# Access Compliance Report

### (Curb Ramps)

Intersection ID: 22317	Main Street: SHARON_RD	Cross Street: SHARON_ACRES_RD	Location: NW
ADA ID: 4BAB84AEBCA5	Ramp Type: Perp	Initial Pass/Fail: Fail	Overall Compliance: No
Severity Score: 21.25			
Codes/Mitigation Info/Possible Solution		Field Measurements/Component Compliance

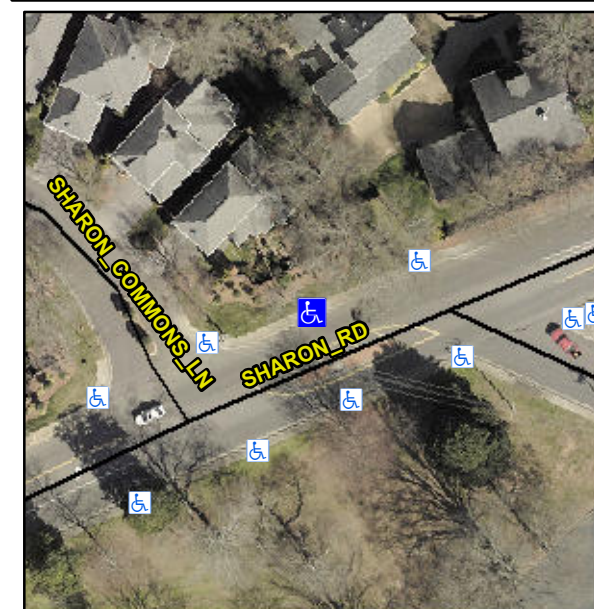
**Not Found, R304.5.1, R304.2.2**

Compliance	Description	Data	Compliance	Description	Data
N/A	Ramp Length (in)	60.0	No	Ramp Slope (%)	8.8
No	Ramp Width (in)	47.0	Yes	Ramp XSlope (%)	1.9
N/A	Flare Type LT	N/A	N/A	Flare Type RT	N/A
N/A	Flare Slope LT (%)	N/A	N/A	Flare Slope RT (%)	N/A
N/A	Flare Traversable LT?	N/A	N/A	Flare Traversable RT?	N/A
N/A	Landing Length (in)	N/A	N/A	DWS Provided?	N/A
N/A	Landing Width (in)	N/A	N/A	DWS Contrast?	N/A
N/A	Landing Slope (%)	N/A	N/A	DWS Length (in)	N/A
N/A	Landing X Slope (%)	N/A	N/A	DWS Full Width?	N/A
N/A	Landing Curb? (Y/N)	N/A	N/A	DWS Offset (in)	N/A
N/A	Shared Landing?	N/A			
N/A	Gutter Ponding?	N/A	N/A	Gutter Slope (%)	N/A
N/A	Gutter Lip Ht (in)	N/A	N/A	Gutter X Slope (%)	N/A
N/A	Painted X Walk1?	No	N/A	Painted X Walk2?	N/A
	X Walk 1 Direction	To S		X Walk 2 Direction	N/A
N/A	X Walk 1 Width (in)	N/A	N/A	X Walk 2 Width (in)	N/A
	X Walk 1 Slope (%)	5.3		X Walk 2 Slope (%)	N/A
	X Walk 1 X Slope (%)	0.5		X Walk 2 X Slope (%)	N/A

**Remove & Replace Entire Ramp.**
